MIDLAND ENERGY CENTER GWO 7020
MEETING NOTES FOR APRIL 7, 1983, AND MARCH 7-8, 1983
DISCUSSIONS BETWEEN CPCO AND NRC
File: 0485.21 UFI: 42*05*22*04 Serial: CSC-6661
50*31*01

Notes of Telecon with NRC on April 5 & 7, 1983.

Subject: Soils Remedial Work, Auxiliary Building Underpinning Design Documents.

Proposed Revisions
to Appendix - D

Pier No. E 12 **
 Date 3-18-83
 Drawn By SW HUNT
 Job No. 7220

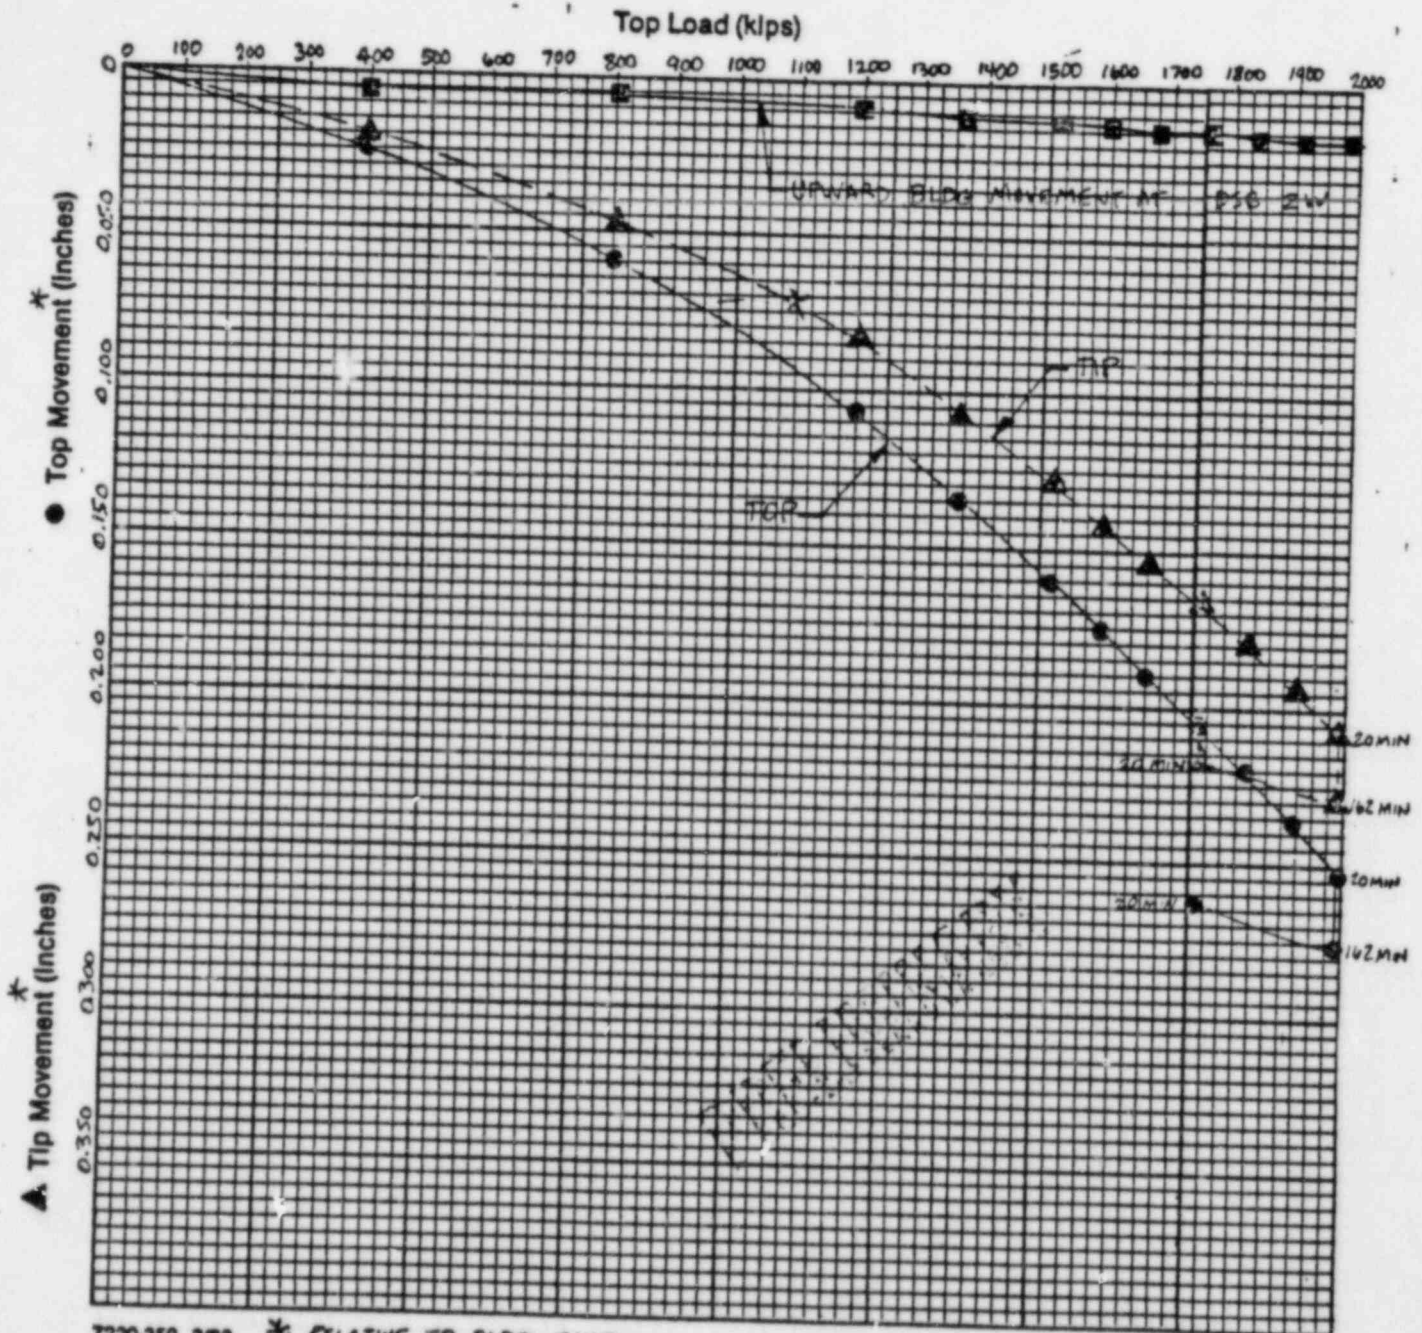
- a) Pier Load Test Data - Top Load versus settlement for Piers E12, W9, E9, W12 (4 sheets).
- b) Plot of bearing pressure vs tip deflection, composite curve for Piers E/W-9 & E/W-12.
